Modification	At what stage is this document in the process?
<p><b>DCRP/MP/20/06 Report to Authority</b></p> <p>Modifications to Storage within the existing Distribution Code documentation.</p>	<div style="display: flex; flex-direction: column; align-items: flex-end;"> <div style="border: 1px solid #ccc; padding: 5px; margin-bottom: 5px; border-radius: 5px;">01 Modification</div> <div style="border: 1px solid #ccc; padding: 5px; margin-bottom: 5px; border-radius: 5px;">02 DCRP report</div> <div style="border: 1px solid #ccc; padding: 5px; margin-bottom: 5px; border-radius: 5px;">03 Public Consultation</div> <div style="border: 2px solid #008000; padding: 5px; margin-bottom: 5px; border-radius: 5px;">04 Final Modification Report</div> </div>
<p>The purpose of this document is to assist the Authority in its decision to implement the proposed modification to the Distribution Code to accommodate energy storage devices. The proposed modification aims to remove the current exemptions applied to storage within existing Distribution Code documents.</p> <p><b>Date of publication: 16 June 2021</b></p>

<p><b>Recommendation</b></p> <p>The Distribution Code Review Panel (DCRP) recommend that th

**Figure 2 – Change in Active Power output with falling frequency**

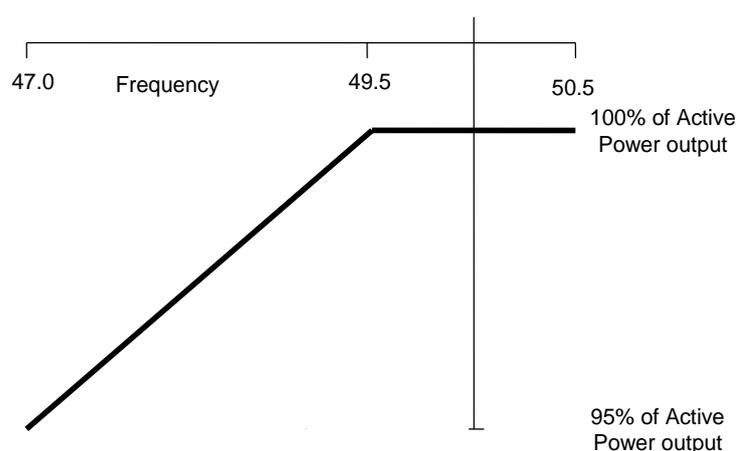
Section 9.4.2 of G98 has new text covering device behaviour during falling frequency:

The **Micro-generator** shall be capable of maintaining constant output at its **Registered Capacity** regardless of changes in frequency in the range 49.5 – 50.4 Hz. Below 49.5 Hz, the power output should not drop by more than pro-rata with frequency, ie the maximum permitted requirement is 100% power at 49.5 Hz falling linearly to 95% power at 47.0 Hz as illustrated in Figure 2.

**Figure 3 Change in Active Power of Electricity Storage Device with falling frequency (not to scale)**

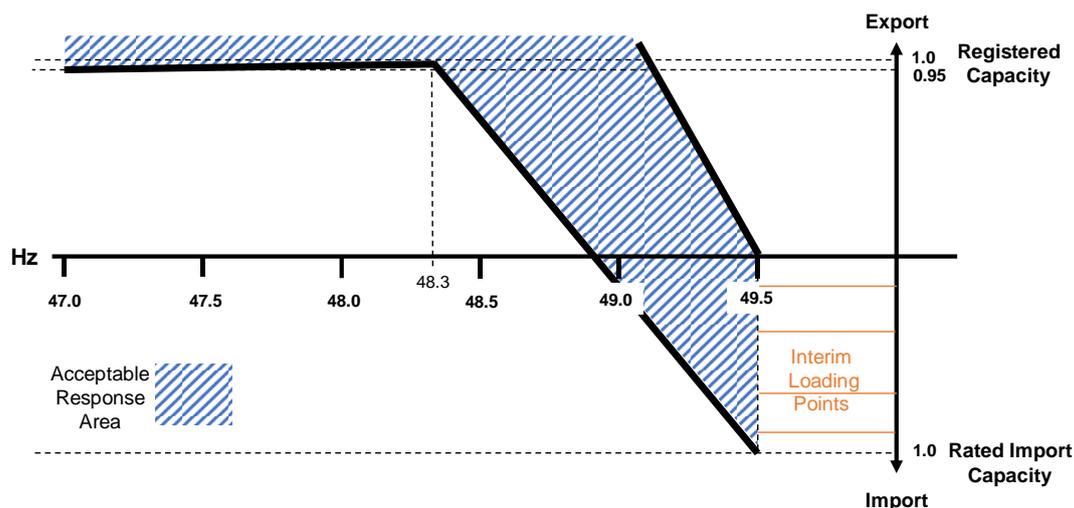
This paragraph describes an optional performance characteristic as discussed in the foreword. A **Micro-generating Plant** that incorporates an **Electricity Storage** device can support the **Total**

**System** by being arranged to automatically respond to falling frequency in line with the characteristic of Figure 3.

The required characteristics are:

- When the frequency falls to 49.5 Hz the automatic response shall start;
- The frequency response characteristic shall be within the shaded area of Figure 3;
- If the **Electricity Storage** device is not capable of moving from an import level to an appropriate export level within 20 s of the frequency falling to 49.2 Hz, then it shall cease to import; and
- If the **Electricity Storage** device has not achieved at least zero **Active Power** import when the frequency has reached 48.9 Hz it shall cease to import immediately.

**Figure 6.8. Example: Existing 3 x 20 kW Electricity Storage devices to EREC G59 plus later addition of 3 x 10 kW Electricity Storage devices with own Inverters**

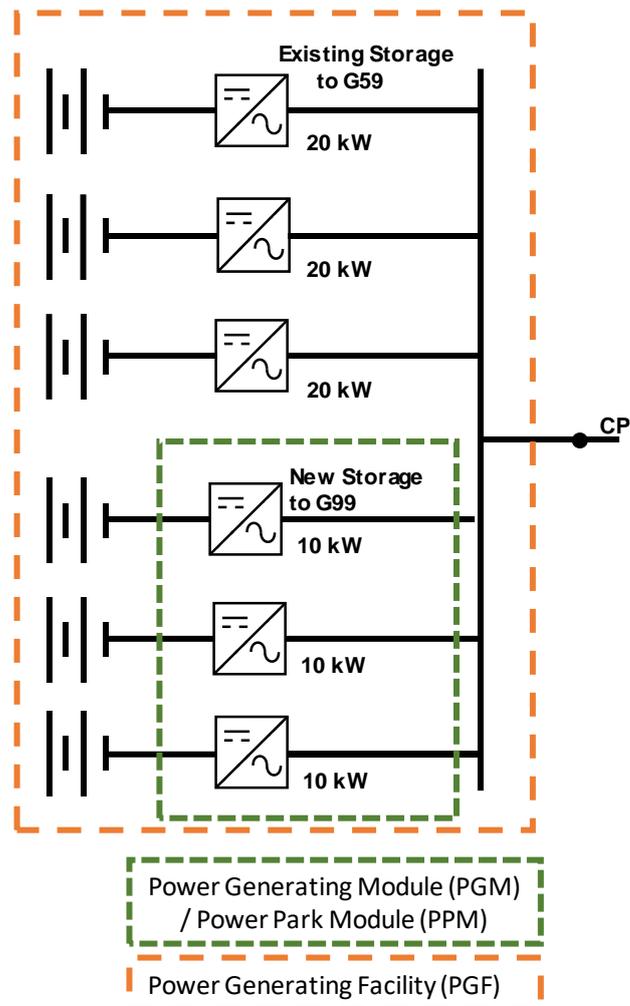
Figures 6.8 – 6.12 are proposed to provide examples for electricity storage devices to be connected, this will result in the current figure 6.8 becoming 6.13 in amendment 7. Figures 6.8 – 6.12, along with new accompanying text as shown below:

**Figure 6.10 Example of a Vehicle to Grid Electric Vehicle where the charging device is included in the EV and there is a stationary Electricity Storage device** Error! Bookmark not defined. **and a solar PV Power Park Module at the same premises**

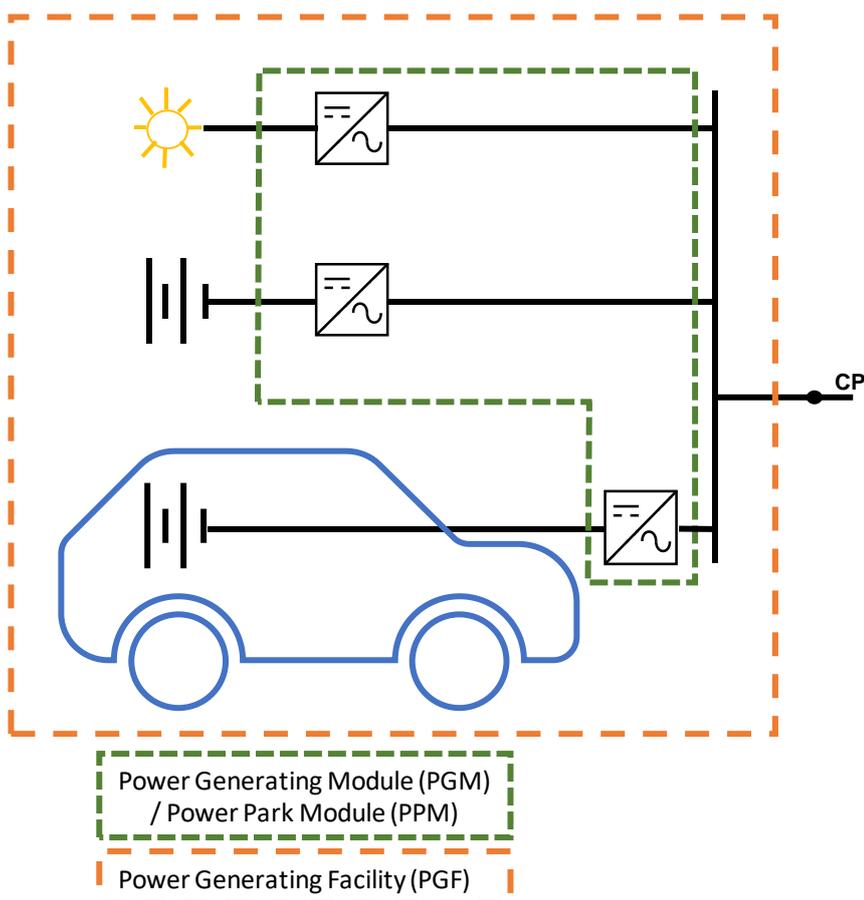
The **Vehicle to Grid Electric Vehicle** is a **Power Generating Unit**. The **Power Generating Module** is comprised of the stationary **Electricity Storage** device, the solar PV **Power Park Module** and the **Vehicle to Grid Electric Vehicle**.

Before a **Vehicle to Grid Electric Vehicle** is connected to the fixed installation the **Customer** must ensure there is an appropriate **Connection Agreement** with the **DNO** and that the whole **Power Generating Module** is compliant with this EREC G99.

**Figure 6.11 Example of a Vehicle to Grid Electric Vehicle where the Inverter is located in the Customer's Installation and there is a stationary Electricity Storage device** <sup>Error!</sup> **and a solar PV Power Park Module at the same premises.**

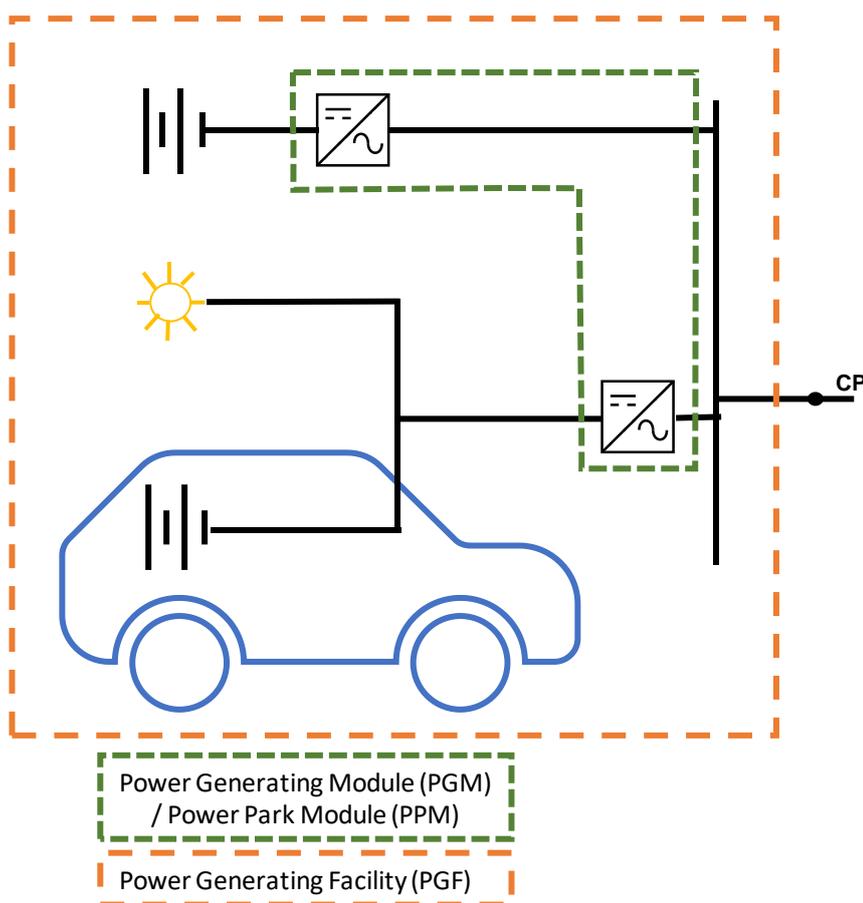
The **Vehicle to Grid Electric Vehicle** charging device in the **Customer's Installation** is a **Power Generating Unit**. The **Power Generating Module** is comprised of the stationary **Electricity Storage** device, the solar PV **Power Park Module** and the **Vehicle to Grid Electric Vehicle Power Generating Unit**.

Before an **Vehicle to Grid Electric Vehicle** is connected to the fixed installation the **Customer** must ensure there is an appropriate **Connection Agreement** with the **DNO** and that the whole **Power Generating Module** is compliant with EREC G99.

**Figure 11.2 Change in Active Power of Electricity Storage Device with falling frequency (not to scale)**

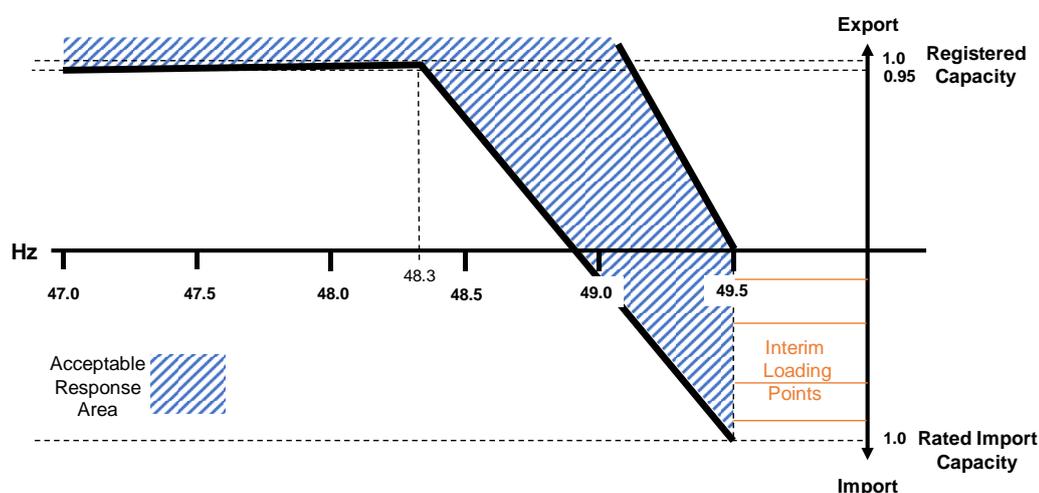
The wording ‘frequency characteristic’ has been removed from section 11.2.3.2 and new text shall be added in section 11.2.3.3 as follows:

This paragraph describes an optional performance characteristic as discussed in the foreword. **Electricity Storage Power Generation Modules** can support the **Total System** by being arranged to automatically respond to falling frequency in line with the characteristic of Figure 11.2 until the stored energy is depleted.

The characteristics are:

- When the frequency falls to 49.5 Hz the automatic response shall start;
- The frequency response characteristic shall be within the shaded area of Figure 11.2;
- If the **Electricity Storage** device is not capable of moving from an import level to an appropriate export level within 20 s of the frequency falling to 49.2 Hz, then it shall cease to import; and
- If the **Electricity Storage** device has not achieved at least zero **Active Power** import when the frequency has reached 48.9 Hz it shall cease to import immediately.

**Figure 12.2 Change in Active Power of Electricity Storage Device with falling frequency (not to scale)**

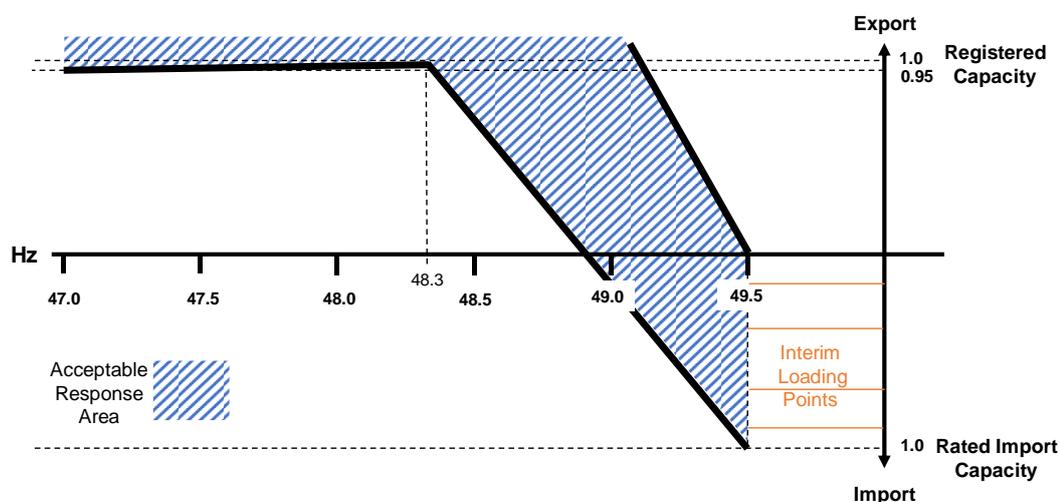
New text has been added in section 12.2.3.3 as follows:

This paragraph describes an optional performance characteristic as discussed in the foreword. **Electricity Storage Power Generation Modules** can support the **Total System** by being arranged to automatically respond to falling frequency in line with the characteristic of Figure 12.2 until the stored energy is depleted.

The characteristics are:

- (a) When the frequency falls to 49.5 Hz the automatic response shall start;
- (b) The frequency response characteristic shall be within the shaded area of Figure 12.2;
- (c) If the **Electricity Storage** device is not capable of moving from an import level to an appropriate export level within 20 s of the frequency falling to 49.2 Hz, then it shall cease to import; and
- (d) If the **Electricity Storage** device has not achieved at least zero **Active Power** import when the frequency has reached 48.9 Hz it shall cease to import immediately.

**Figure 13.2 Change in Active Power of Electricity Storage Device with falling frequency (not to scale)**

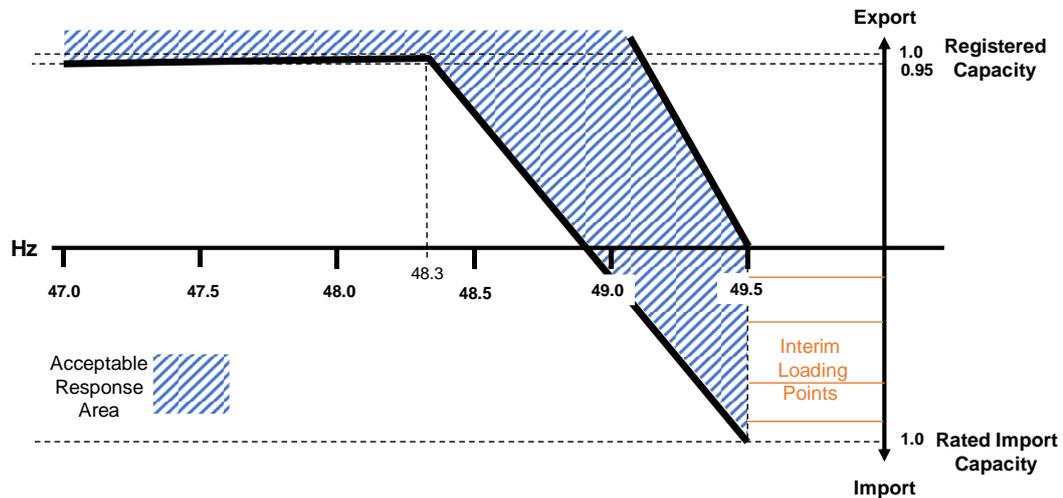
New text has been added in section 13.2.3.3 as follows:

This paragraph describes an optional performance characteristic as discussed in the foreword. **Electricity Storage Power Generation Modules** can support the **Total System** by being arranged to automatically respond to falling frequency in line with the characteristic of Figure 13.2 until the stored energy is depleted.

The characteristics are:

- (e) When the frequency falls to 49.5 Hz the automatic response shall start;
- (f) The frequency response characteristic shall be within the shaded area of Figure 13.2;
- (g) If the **Electricity Storage** device is not capable of moving from an import level to an appropriate export level within 20 s of the frequency falling to 49.2 Hz, then it shall cease to import; and
- (h) If the **Electricity Storage** device has not achieved at least zero **Active Power** import when the frequency has reached 48.9 Hz it shall cease to import immediately.

**Figure A.4.2. Example: Existing 60 kW Type A Power Park Module to EREC G99 plus later addition of 3 x 10 kW Electricity Storage devices with own Inverters**

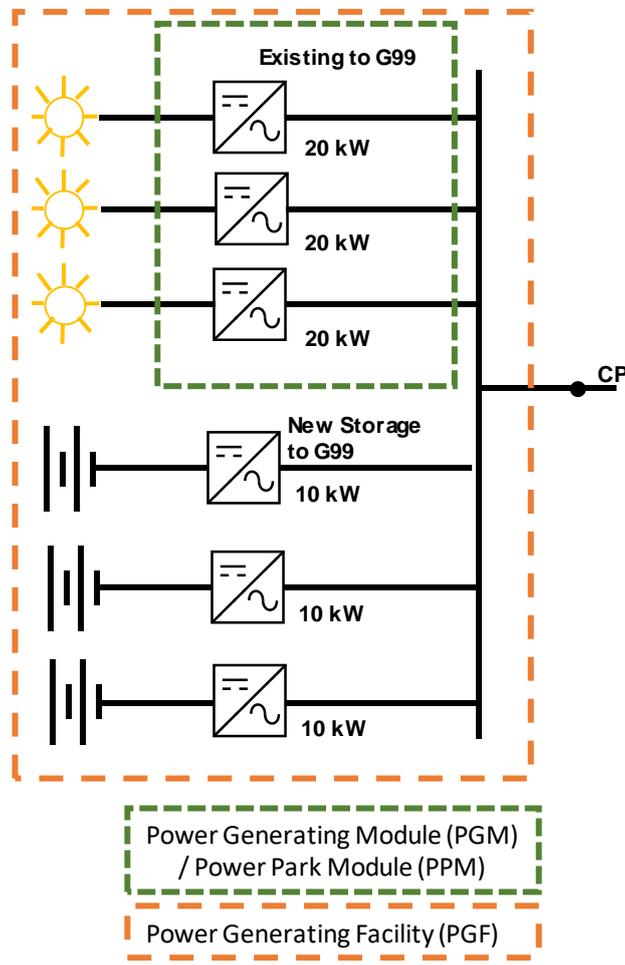
A.4.2.4.1 Scenario 7 and Figure 6.7: The **Electricity Storage** devices are not included in the **Power Park Module** in this example, hence this example is a 60 kW **Power Park Module** and a 90 kW **Power Generating Facility**. This is illustrated in Figure A.4.2.

**Figure A.4.3. Example: Existing 3 x 20 kW Electricity Storage devices to EREC G59 plus later addition of 3 x 10 kW Electricity Storage devices with own Inverters**

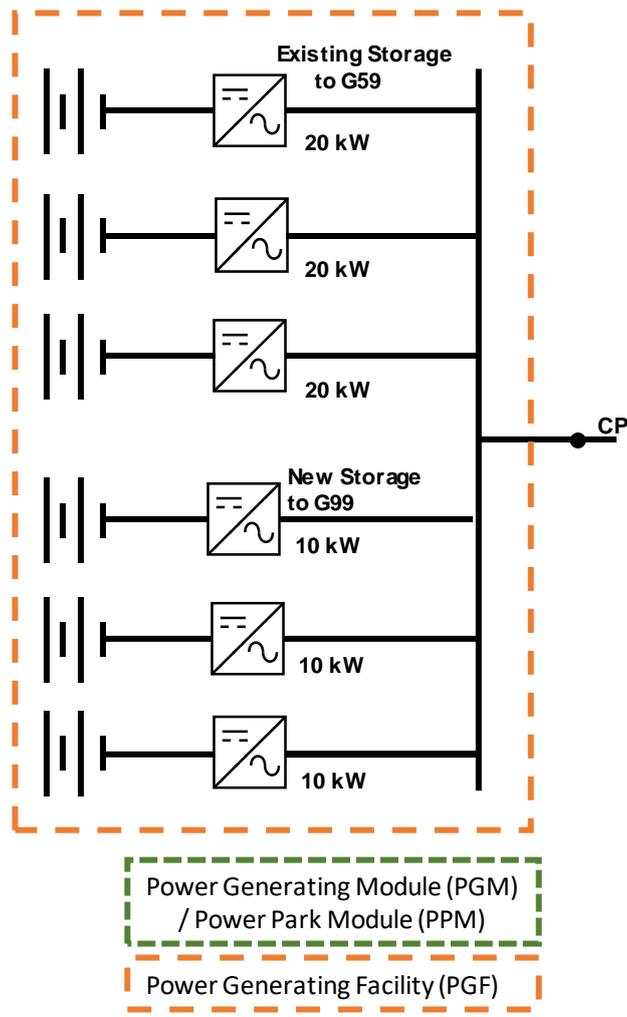
A.4.2.4.2 Scenario 8 and Figure 6.8: The later addition of 3 x 10kW **Electricity Storage** devices do not form a **Type A Power Park Module** and hence this example is 60 kW **Electricity Storage** + 30 kW **Electricity Storage** = 90 kW **Power Generating Facility**. This is illustrated in Figure A.4.3.

**Figure A.4.4. Example: Existing 3 x 20 kW Electricity Storage devices to EREC G99 plus later addition of 3 x 10 kW Electricity Storage devices with own Inverters**

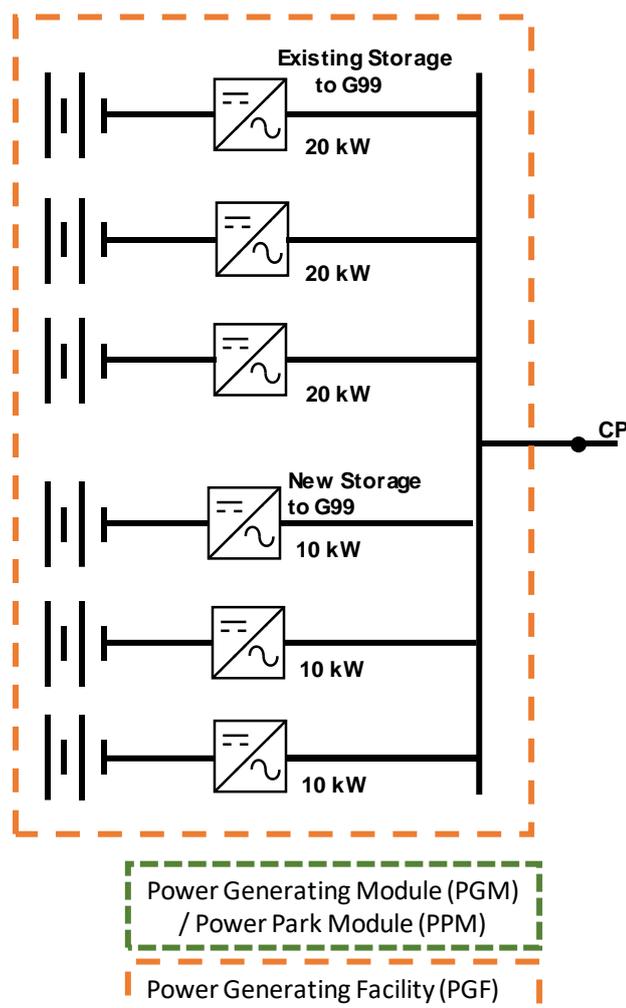
**A.4.2.4.3 Scenario 9 and Figure 6.9: The existing Electricity Storage devices and the later addition of 3 x 10kW Electricity Storage devices do not form a Type A Power Park Module and hence this example is 60 kW Electricity Storage + 30 kW Electricity Storage = 90 kW Power Generating Facility. This is illustrated in Figure A.4.4.**
